**OHIO TURNPIKE AND  
INFRASTRUCTURE COMMISSION**

**ADDENDUM NO. 1**  
**ISSUED JANUARY 23, 2020**

**PROJECT NO. 59-20-02**  
**PART A: REPAIRS AND RESURFACING**  
**EASTBOUND AND WESTBOUND ROADWAYS**  
**MILEPOST 118.80 TO MILEPOST 127.23**  
**ERIE COUNTY, OHIO**  
**PART B: SLOPE REPAIRS**  
**EASTBOUND ROADWAY**  
**MILEPOST 121.2 AND MILEPOST 123.1**  
**ERIE COUNTY, OHIO**

7	PROJECT 59-20-02A	GENERAL NOTES	DESIGNED JJS	CHECKED CAM	NO. △	REVISIONS ADDENDUM NO. 1	BY JJS	DATE 1/23/20	DESIGN AGENCY
14			DRAWN JJS	IN CHARGE ADY	.	.	.	.

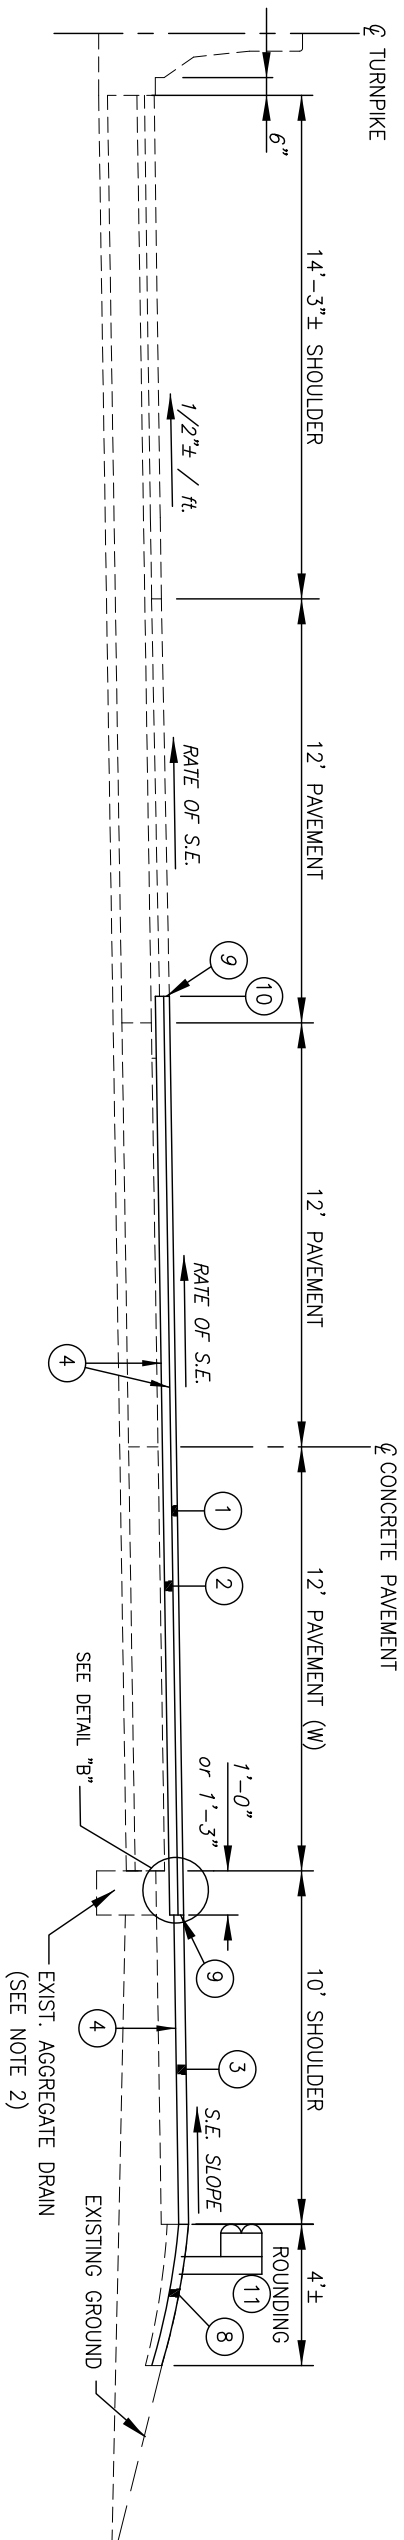
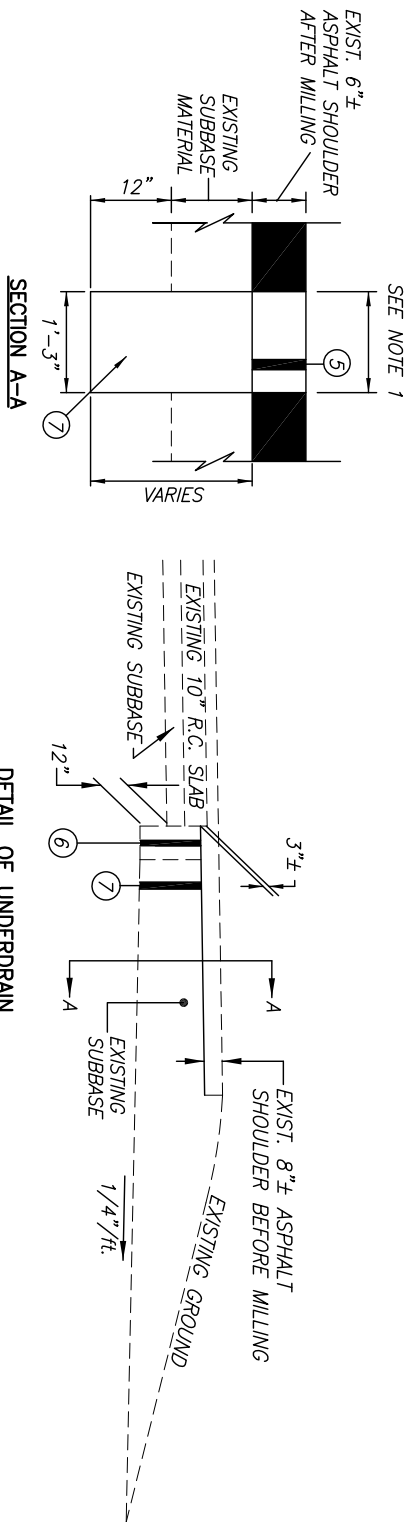
**Q#14 Plans show removing and replacing approach slabs in the Left lanes in various locations. 1) Currently there is no asphalt setup to transition the new approach slab to the existing**

**asphalt. Is the intent to patch in the gap between the existing asphalt and new approach slab or will quantities be established to mill and fill transitions to the new approach slabs? 2) Should the sequence for removing and replacing the approach slabs happen during Stage 1 or after Stage 2?**

*A#14 Plan Sheet 7 of 14 has been reviewed and revised to include a plan note which includes Item 254, Pavement Planing, Asphalt Concrete (T=2") and Item SP 404, Asphalt Concrete Surface Course, Using Crushed Stone, PG 64-22 for patching/repairing the transition area for the left lane approach slab replacements, as called for in the Plans. This work may be performed during Stage 1 Work or it may be performed after Stage 2 Work is complete. Furthermore, Plan Sheet 12 of 14, the the Bid Schedule of Items and the Estimated Quantities Worksheet has been reviewed and revised to increase the quantity of Reference No. 24, Item 254, Pavement Planing, Asphalt Concrete (T=2") and Reference No. 28, Item SP 404, Asphalt Concrete Surface Course, Using Crushed Stone, PG 64-22 for patching/repairing the transition area for the left lane approach slab replacements. Revised Plan Sheets 7 and 12 of 14, the Bid Schedule of Items and the Estimated Quantities Worksheet have been included with this Addendum No. 1.*

LEFT LANE APPROACH SLAB ASPHALT TRANSITION REPAIRS  
A QUANTITY OF ITEM 254, PAVEMENT PLANING, ASPHALT CONCRETE (T=2") AND ITEM SP 404, ASPHALT CONCRETE SURFACE COURSE, USING CRUSHED STONE, PG 64-22 HAVE BEEN ADDED TO THE PLANS TO PATCH/REPAIR PAVEMENT THAT IS DAMAGED DURING THE REMOVAL OF THE APPROACH SLAB IN THE LEFT LANE, AS CALLED FOR IN THE PLANS. FOR PLANNING PURPOSES, IT CAN BE ASSUMED THE PATCH SIZE WILL BE 12'x50' TO AID IN MAKING A SMOOTH TRANSITION FROM THE REPLACED APPROACH SLAB TO THE EXISTING PAVEMENT. LIMITS ARE SUBJECT TO ADJUSTMENT BY THE CHIEF ENGINEER. ALL LABOR, EQUIPMENT, MATERIALS, NON-TRACKING TACK COAT, AND INCIDENTALS NEEDED TO COMPLETE THIS WORK SHALL BE INCLUDED IN THE RESPECTIVE ITEMS.
